**Advanced Passive 1000 (AP1000)  
Generic Technical Specification Traveler (GTST)**

**Title: Changes Related to LCO 3.6.8, Containment Penetrations**

Section 3.6.8 Containment Penetrations

Figure B 3.6.87-1 (page 1 of 1)  
Time Prior to Coolant Inventory Boiling

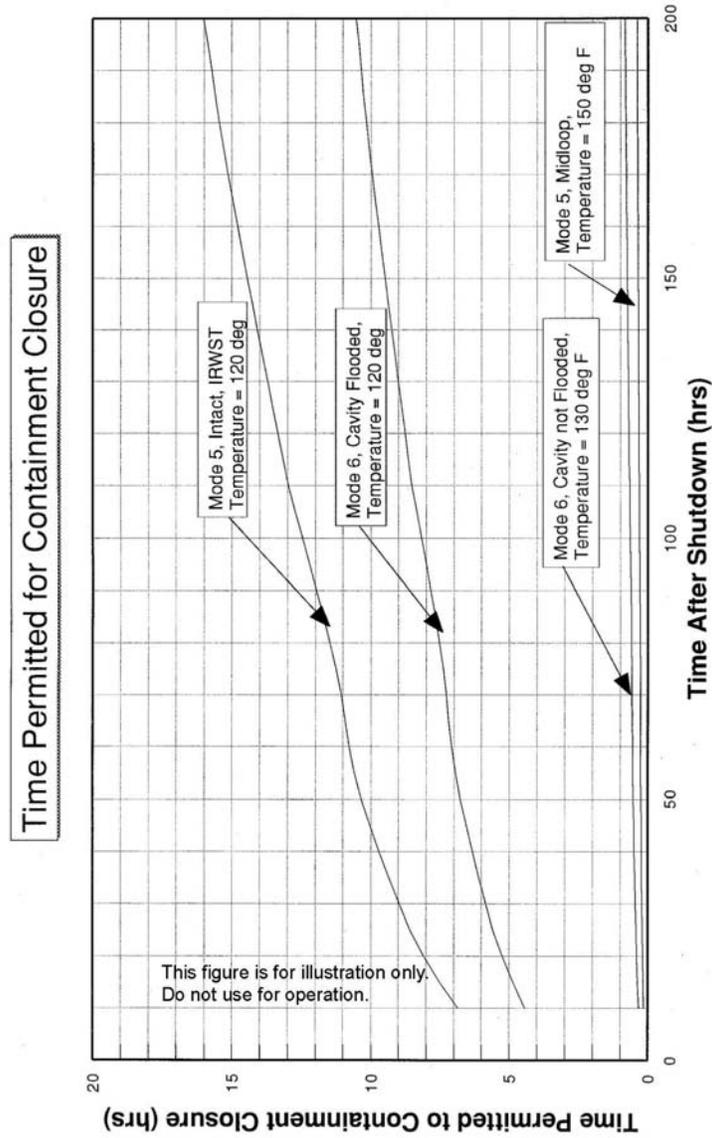
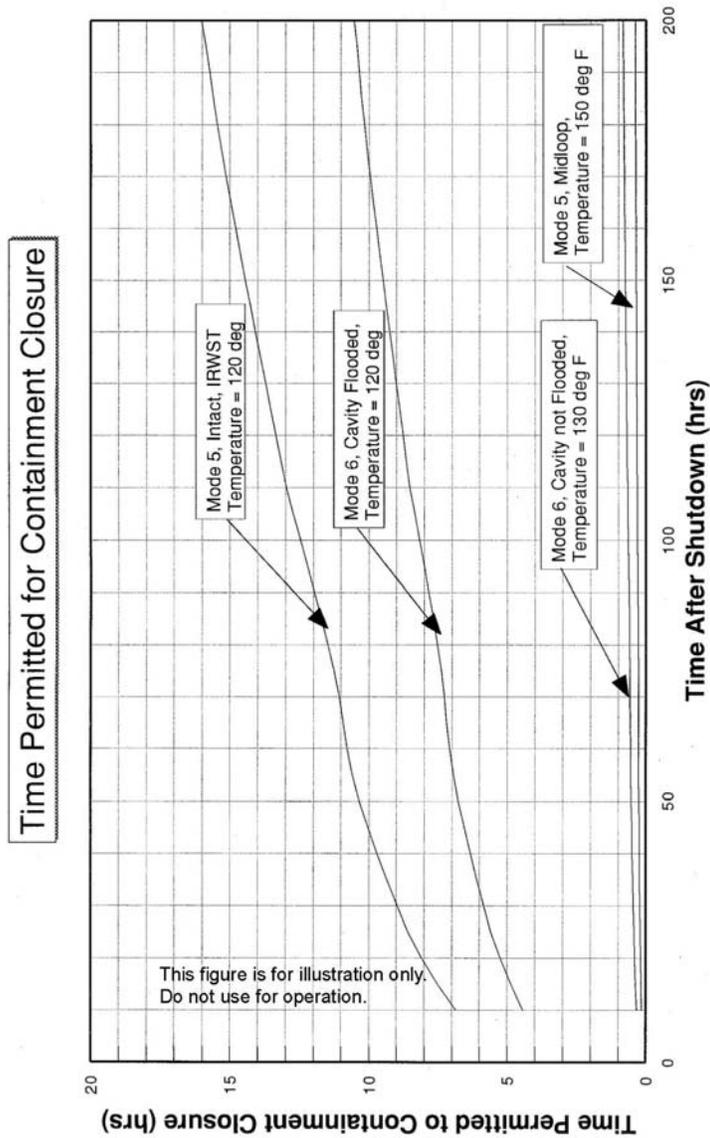
Figure B 3.6.8-1 in the bases is revised by removing brackets from the figure. (COL Item B3.6.8)

VEGP COL Item B3.8.6 removes the brackets from Figure B 3.6.8-1 in the Bases.

VEGP COL Item B3.8.6 removes brackets from Figure B 3.6.8-1 since the figure is for illustration only and should not have been bracketed. VEGP COL Item B3.6.8 (see Reference 2), removal of the Reviewer's Note in B3.6.8 was in error by the applicant. Instead this item was meant to remove the brackets from Figure B 3.6.8-1.

The markup to remove the brackets from figure B 3.6.8-1 was manually done in the Word document.
